WOOLLAM PARK

SUPPLEMENTARY DESIGN PRINCIPLES

RESPONSES TO URBAN DESIGN / LANDSCAPE COMMENTS

**(TO BE READ IN CONJUNCTION WITH DESIGN & ACCESS STATEMENT SUBMITTED WITH
OUTLINE PLANNING APPLICATION 5/2024/2271)**

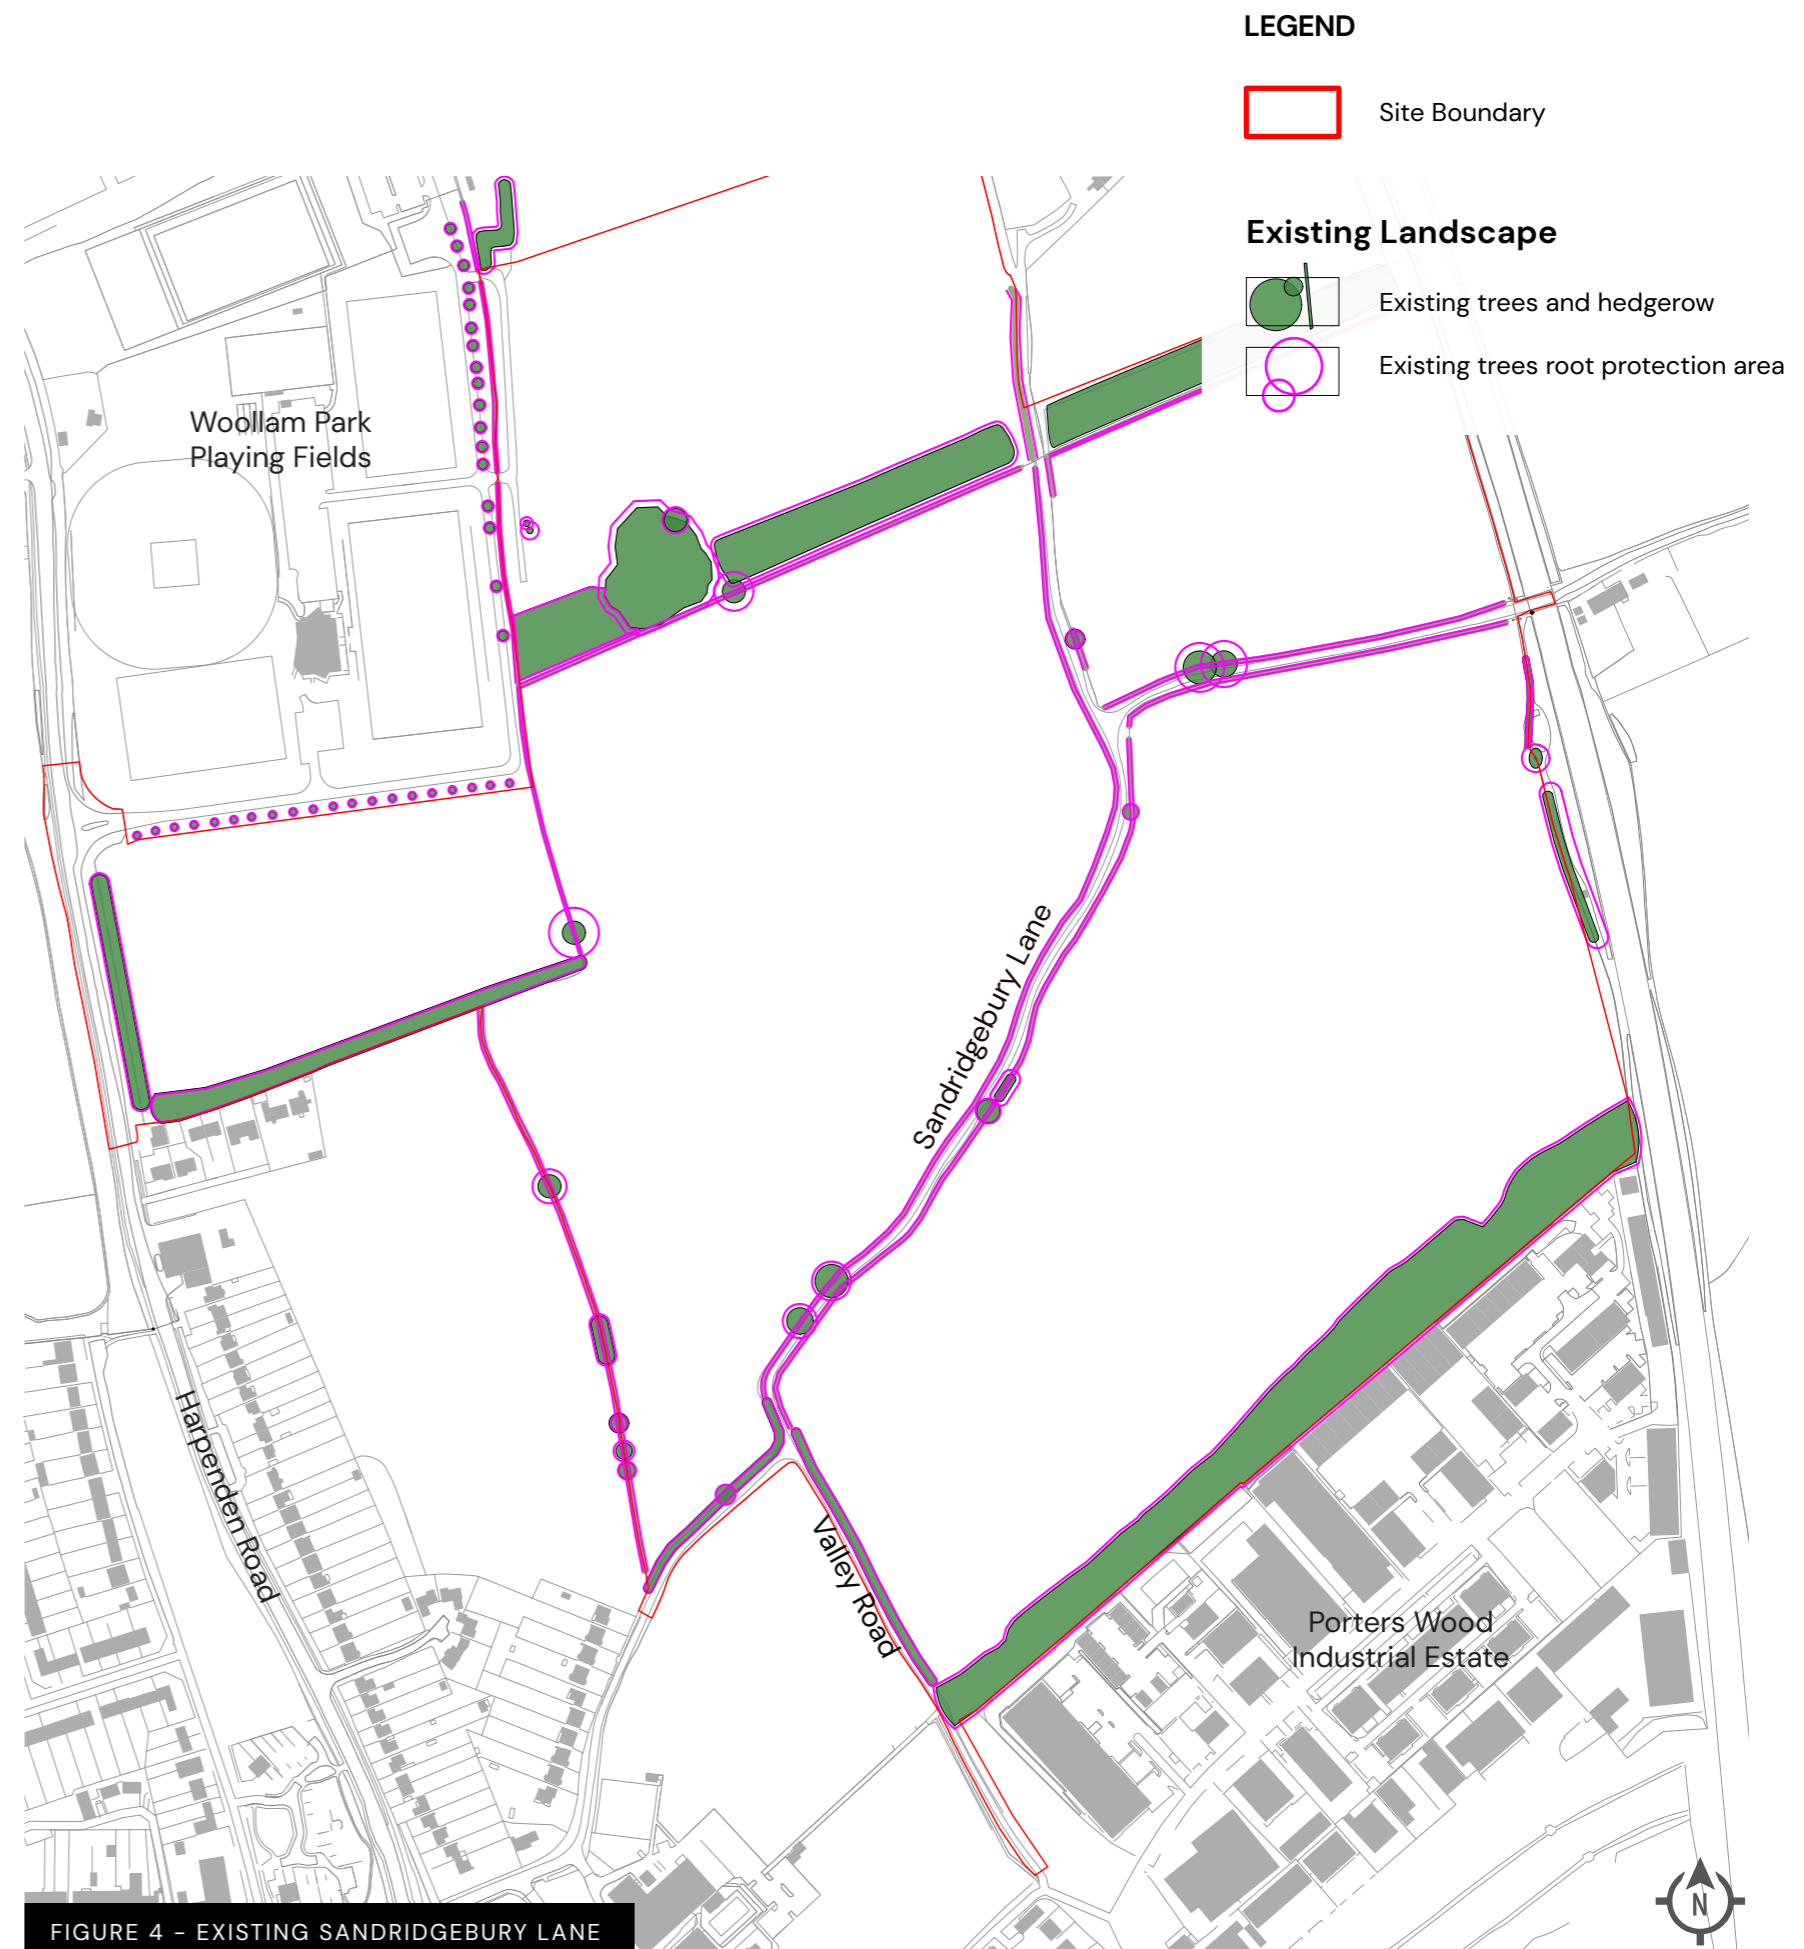
3.14 "During pre-app meetings we discussed at length the suitability of Sandridgebury Lane as an active travel corridor, especially after dark, as it is lined with high hedgerows which will limit overlooking and the habitat value of the hedgerows could limit lighting opportunities. The applicant did a lot of work on this including, discussing in principle a feasible reduction in the height of the hedgerow with HCC ecologist. There are some sections in the DAS (p.126), but they lack annotation to make any real commitment on the proposals. Also, removal of sections of hedgerow and planting of additional hedgerow to compensate? Likewise, I can't find firm commitments on the frontage to the lane: are there front doors, balconies, front gardens? We discussed alternative, after-dark routes, but these are not clear to me in the document? It's difficult to assess this critical element on the information I can find".

Figure 4 (right) and the photograph below show the existing hedgerows and trees on Sandridgebury Lane which is characterised by almost continuous vegetation along both sides of the lane.

FIGURE 18 - WOOLLAM SQUARE CONTEXTUAL ANALYSIS EXAMPLES & PROPOSAL

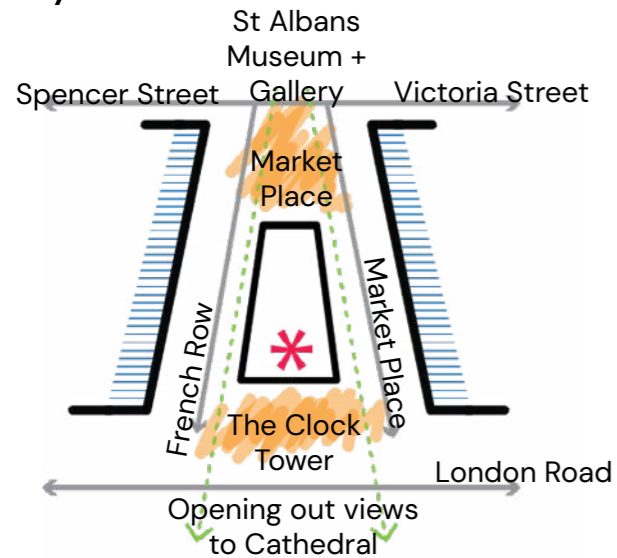
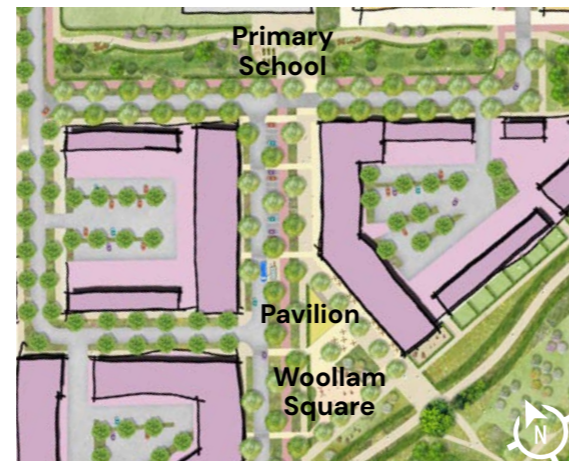
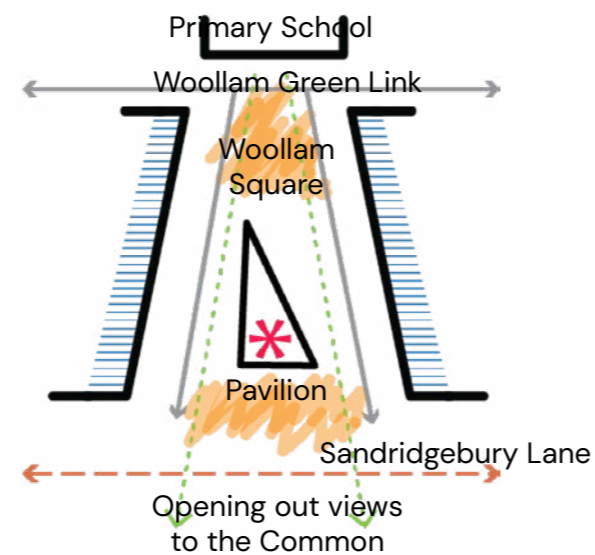
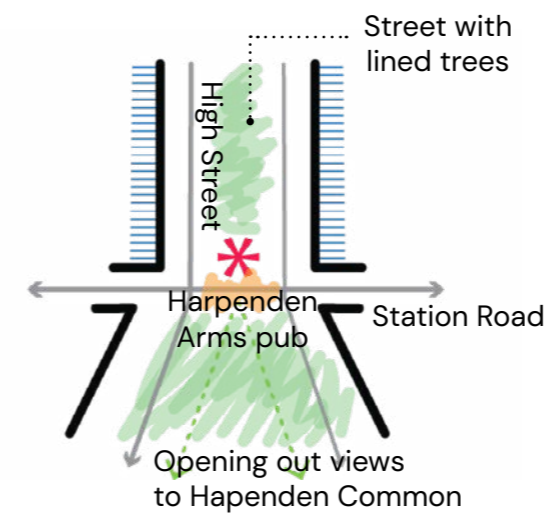
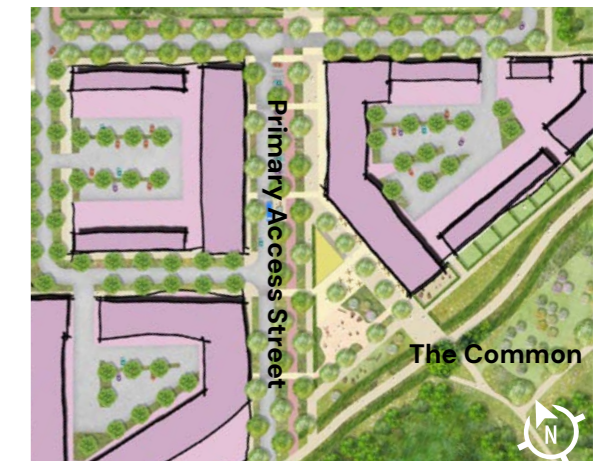
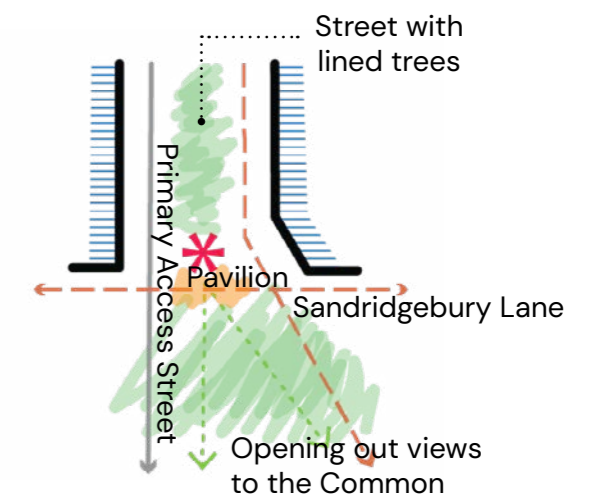
4.11 "Likewise, the form of Woollam Square is regimented in a way not supported by contextual analysis (see examples above & Wheathampstead High Street)".

The proposed design of Woollam Square was discussed in some detail at the Design Review Panel (DRP) on 19 March 2024. A number of built precedents were reviewed to test the Woollam Square proposals through the design development of the space. Figure

FIGURE 19 - ALIGNMENT PROTECTED FOR SURFACE WATER DRAINAGE ILLUSTRATIVE SECTION

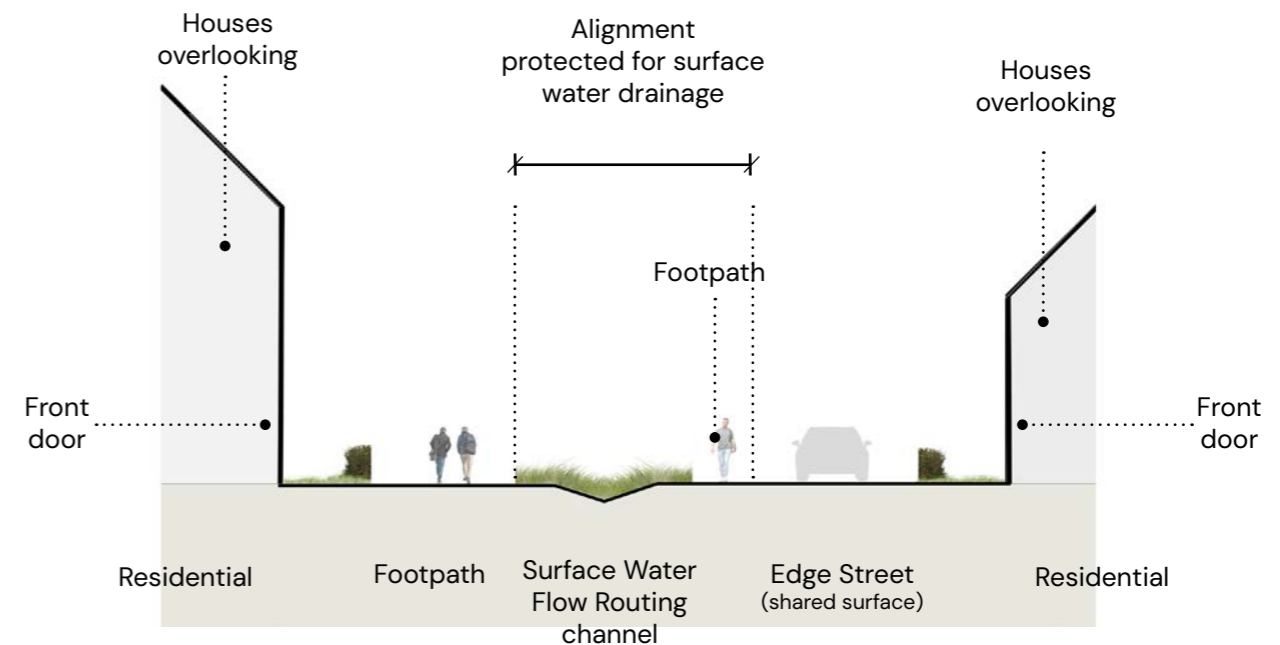
4.14 "Overall, there is a very clear water management diagram which has responded to topography and existing surface water flows to shape the masterplan. However, on the Green and Blue Infrastructure Parameter Plan, there is a zone of "Alignment protected for surface water drainage", which does not seem as integrated in the scheme as the other blue infrastructure".

The submitted Parameter Plan seeks to provide a flexible approach for the future applications, so as not to cause undue problems for delivery at a later date. Figure 19 (below) illustratively shows how the 'alignment protected for surface water drainage' could be integrated to the street scene to permit this surface water movement, connecting into the wider water drainage network across the site.

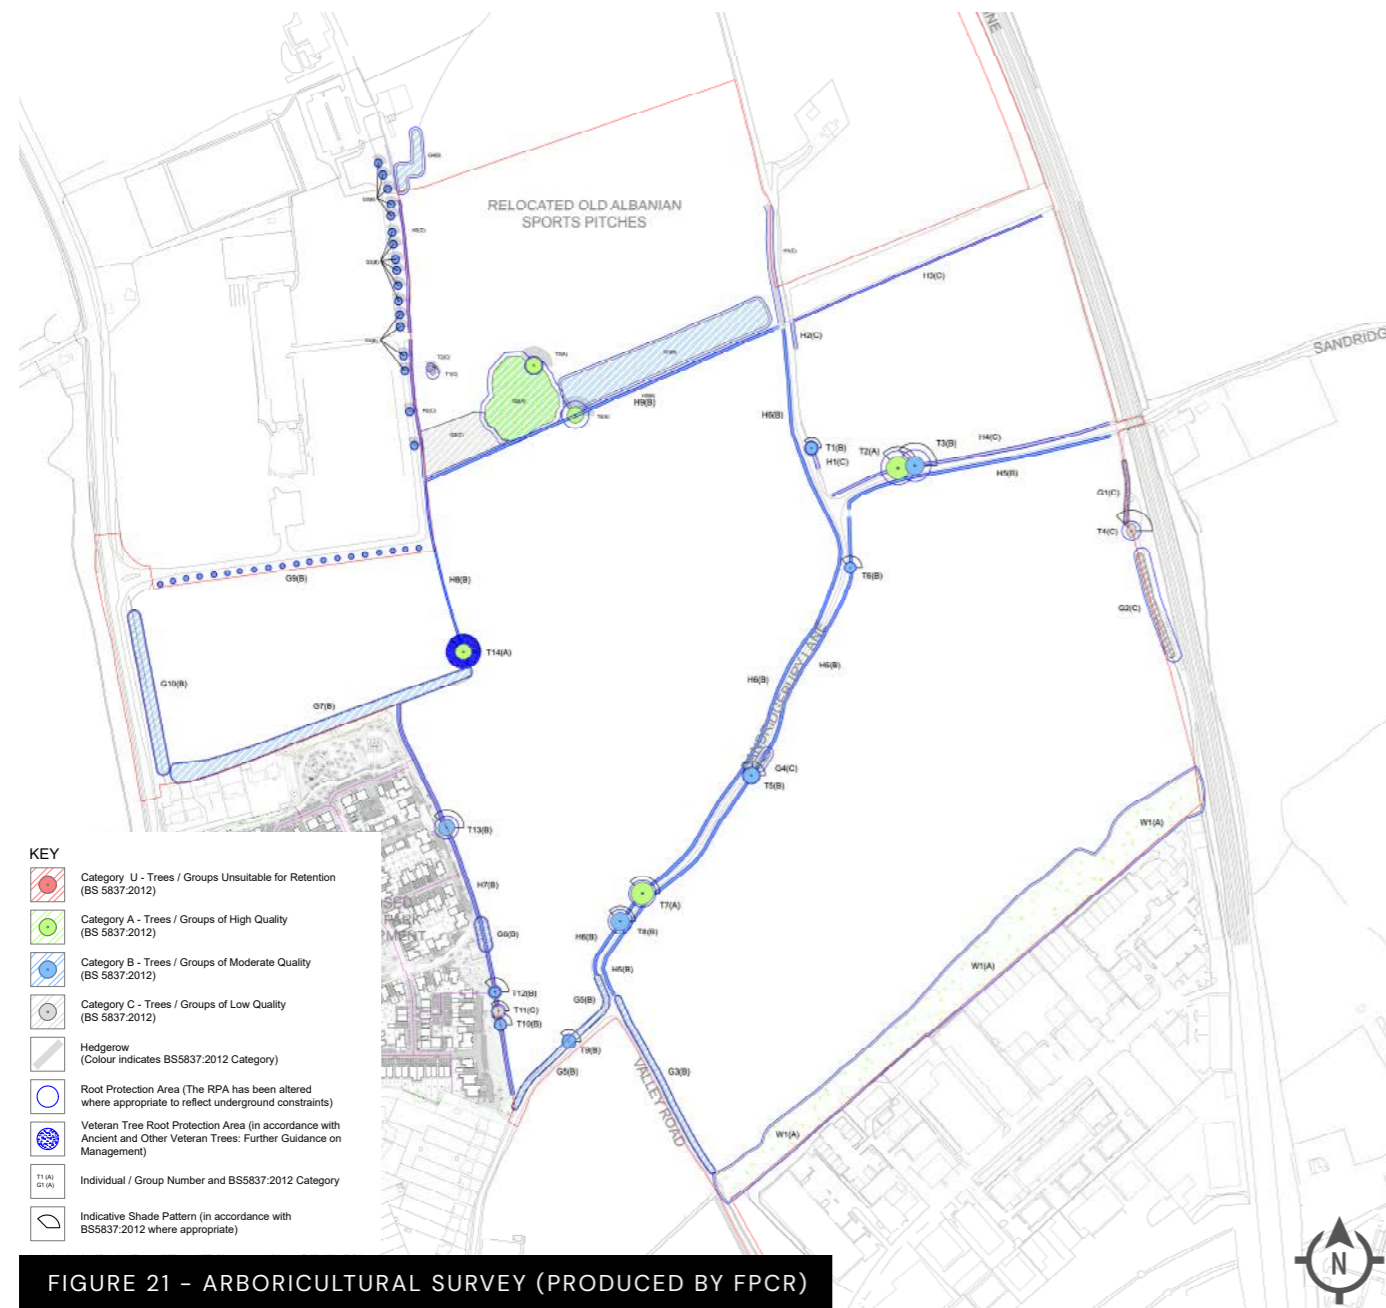
4.16 "Tree removal: the Landscape Framework Plan shows very few existing trees and very few removed. Yet looking at a satellite view of the site there seems to be many more trees and more that would need removal: for instance, where the turning circle on Sandridgebury Lane is proposed".

All potential removals of trees / group of trees / hedgerows are accurately shown on the Tree Removal Plan (Figure 22). This should be read alongside the existing Arboricultural Survey Plan (Figure 21). These plans provide a comprehensive representation of existing vegetation and proposed removals.
